# CHATFIELD STORAGE REALLOCATION PROJECT

## TECHNICAL ADVISORY COMMITTEE (TAC) TAC RECOMMENDATION DOCUMENT - No. 05

SUBJECT: Borrow Area Refinement Rev 03 (Signed)

**Subject:** Earthwork Borrow Areas for Chatfield Reallocation Project

PLUM CREEK MITIGATION  
 GRADING PLAN

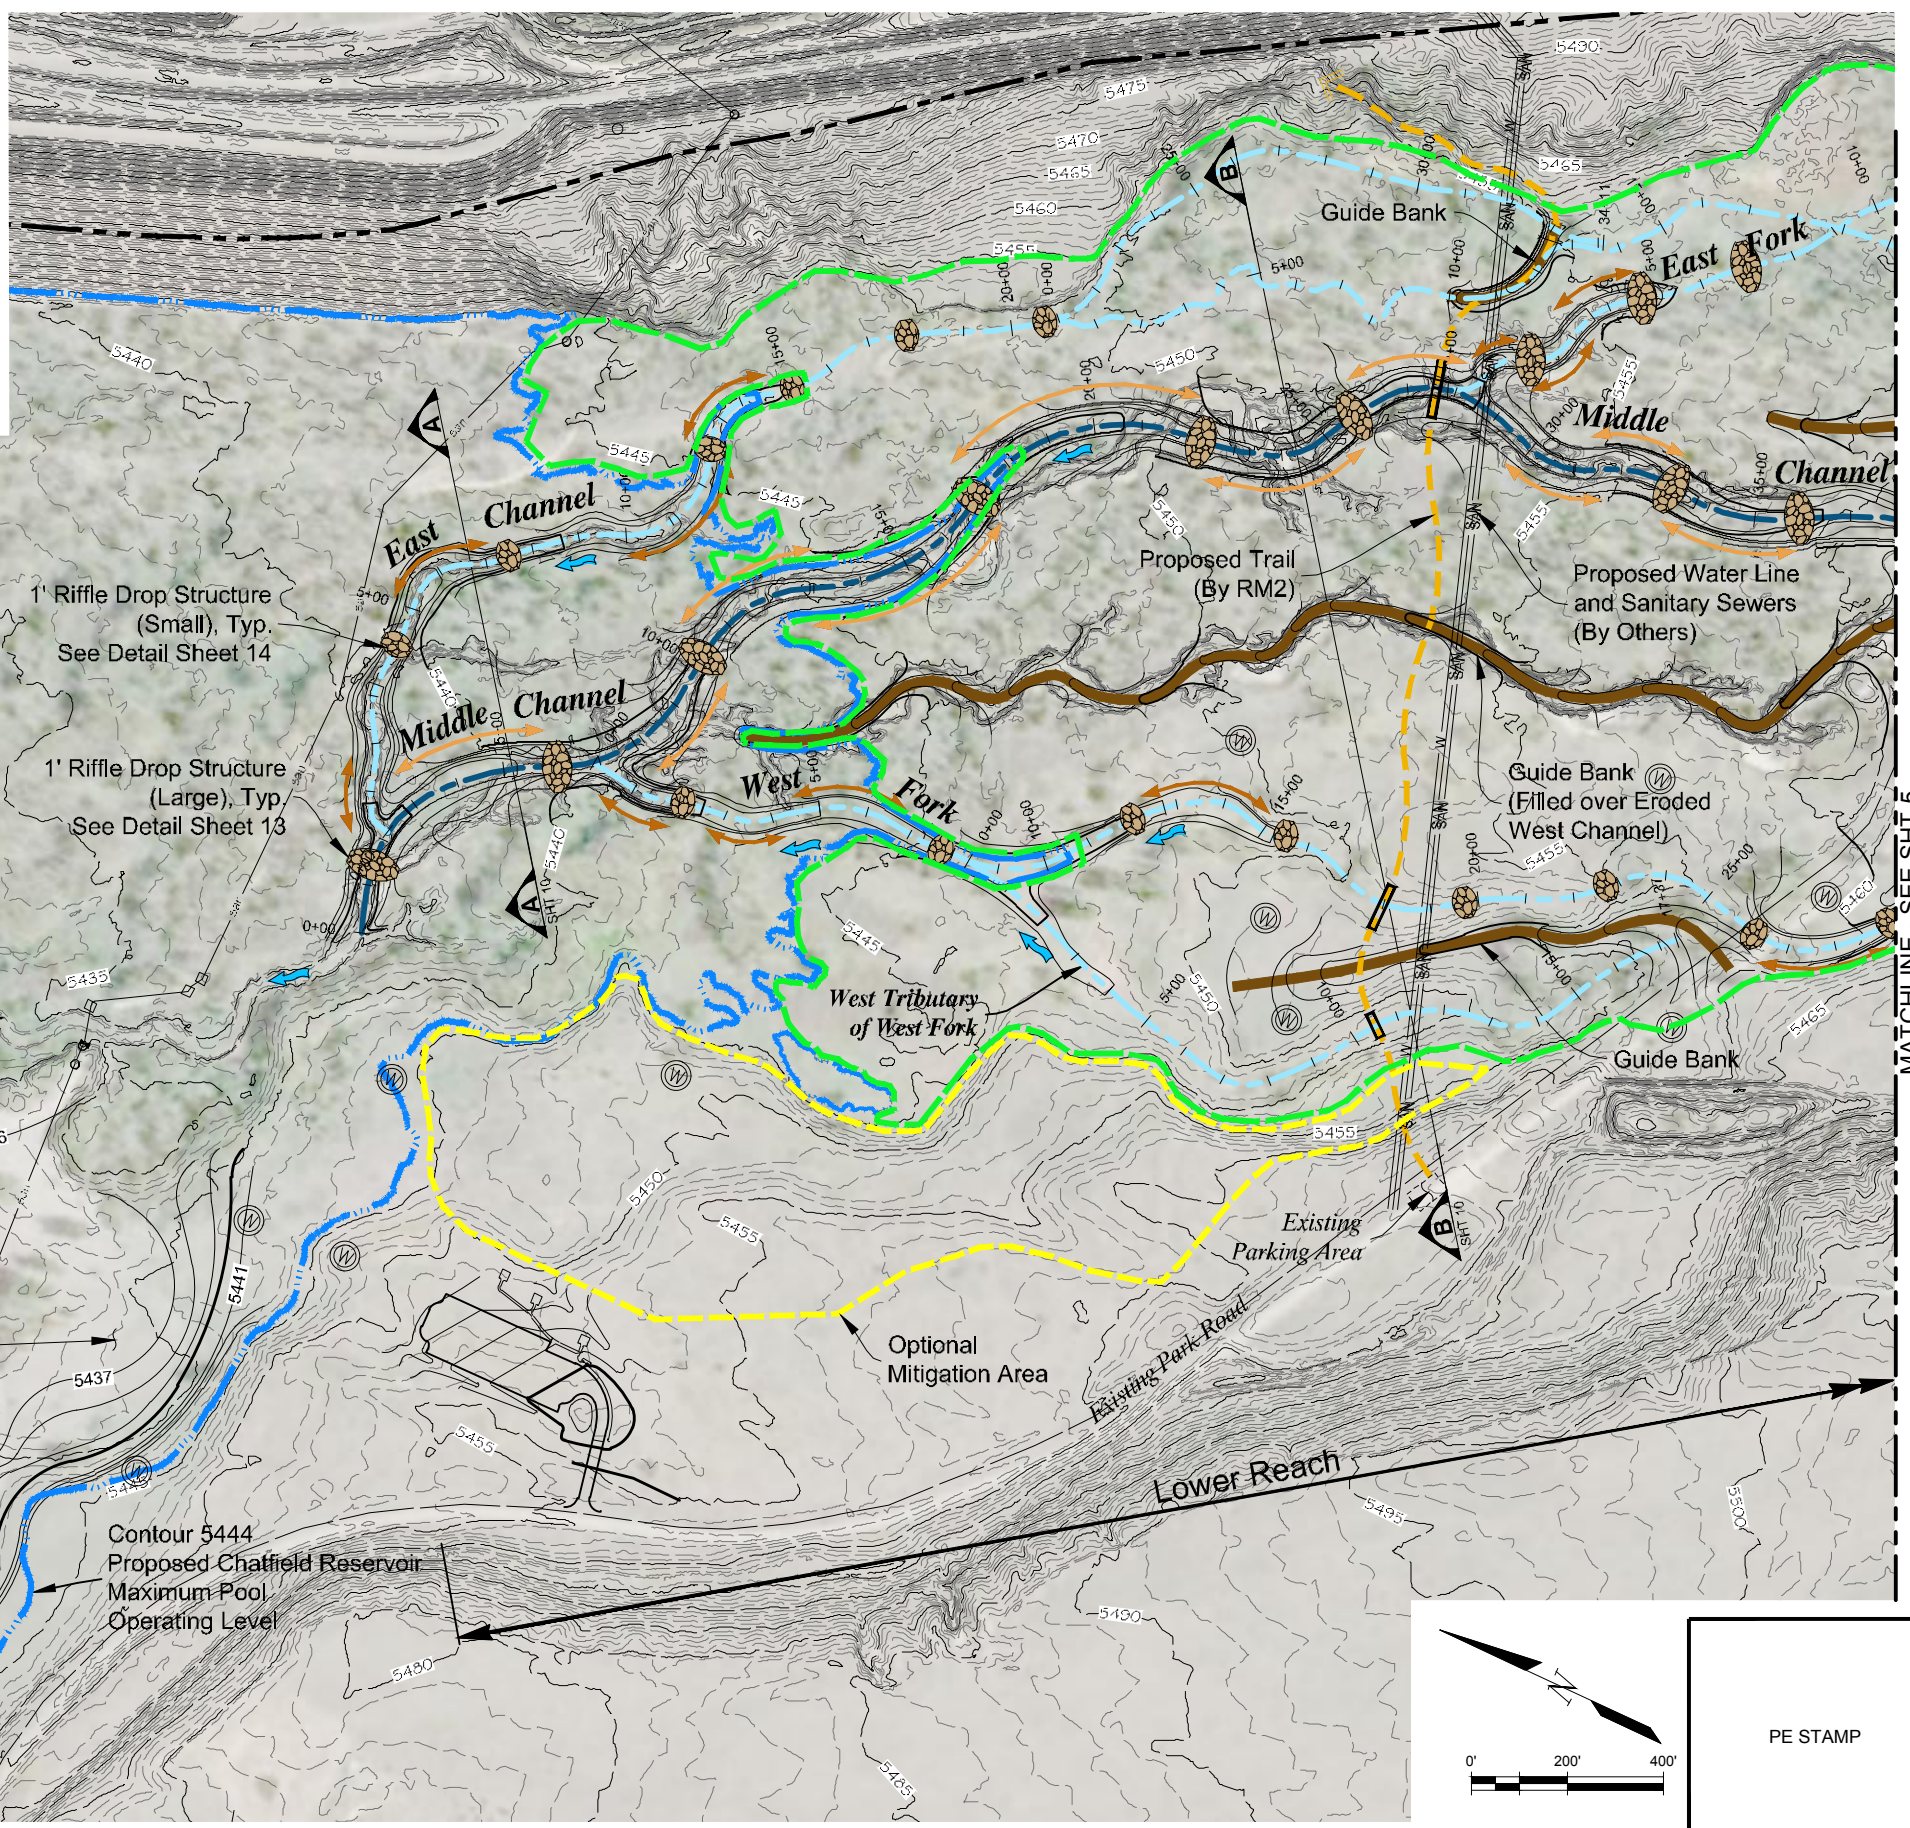
The EM2 preliminary design plans identify two locations that have opportunities to generate fill material for use by RM1 and RM2 in the flood control zone (5444 and above) while providing a location for on-site environmental mitigation (herein referred to as EM2's Borrow Sites). Attached to this memo are two plan sheets from EM2's preliminary design plans that identify these locations by yellow outline (one along Plum Creek and one along S. Platte River).

Moving forward into final design, EM2's Borrow Sites provide an opportunity to generate additional onsite mitigation areas with contiguous riparian habitat and a potential for EFU lift. Borrow Areas 4 and 5 create a disturbance footprint to upland grasslands with no EFU lift. Additionally, attempting to revegetate Borrow Areas 4 and 5 would likely be more difficult than EM2's Borrow Sites because of the loose, dry, sandy soils. Due to their location close to roads and high use areas, Borrow Areas 4 and 5 would be much more visible to park users than EM2's Borrow Sites which are located along the Plum Creek and S. Platte channel corridors.

The TAC recommends adjustment of Borrow Area 4 and the upper part of Borrow Area 5 locations to reflect EM2 recommendations. The TAC further recommends that portions of the current Borrow Area 4 be retained if additional fill material is needed within the Flood Control Zone.
